Access Compliance Report

Public Rights-of-Way

Intersection ID: 27570	Main Street: ALTON_FARM_LN	Cross Street: DEER RIDGE_LN	Location: NE
ADA ID: 0B2D396568FE	Ramp Type: PerpDiag	Initial Pass/Fail: Fail	Overall Compliance: No
Codes/Mitigation Info/Possible Solution		Field Measurements/Component Compliance

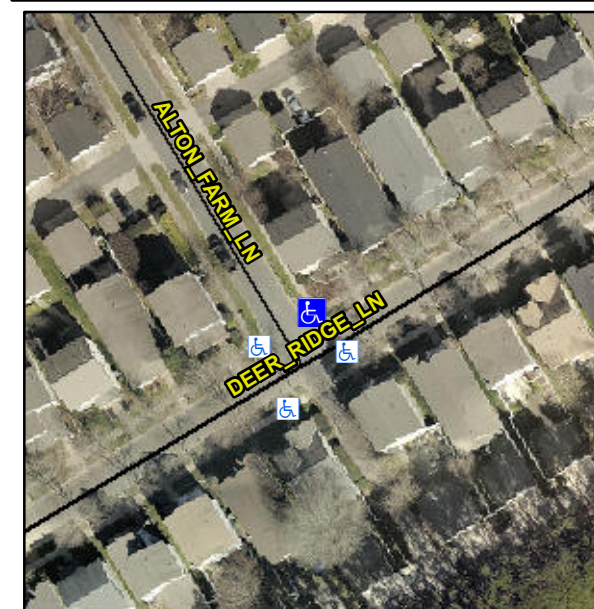
R304.2.2, R304.5.3

Compliance	Description	Data	Compliance	Description	Data
N/A	Ramp Length (in)	59.0	No	Ramp Slope (%)	9.1
Yes	Ramp Width (in)	48.0	No	Ramp XSlope (%)	2.9
N/A	Flare Type LT	N/A	N/A	Flare Type RT	N/A
N/A	Flare Slope LT (%)	N/A	N/A	Flare Slope RT (%)	N/A
N/A	Flare Traversable LT?	N/A	N/A	Flare Traversable RT?	N/A
N/A	Landing Length (in)	N/A	N/A	DWS Provided?	N/A
N/A	Landing Width (in)	N/A	N/A	DWS Contrast?	N/A
N/A	Landing Slope (%)	N/A	N/A	DWS Length (in)	N/A
N/A	Landing X Slope (%)	N/A	N/A	DWS Full Width?	N/A
N/A	Landing Curb? (Y/N)	N/A	N/A	DWS Offset (in)	N/A
N/A	Shared Landing?	N/A			
N/A	Gutter Ponding?	N/A	N/A	Gutter Slope (%)	N/A
N/A	Gutter Lip Ht (in)	N/A	N/A	Gutter X Slope (%)	N/A
N/A	Painted X Walk1?	No	N/A	Painted X Walk2?	No
	X Walk 1 Direction	To SW		X Walk 2 Direction	To SE
N/A	X Walk 1 Width (in)	N/A	N/A	X Walk 2 Width (in)	N/A
	X Walk 1 Slope (%)	1.4		X Walk 2 Slope (%)	1.1
	X Walk 1 X Slope (%)	3.3		X Walk 2 X Slope (%)	1.3

Remove & Replace Curb Ramp With Two New Directional Ramps or Equivalent.
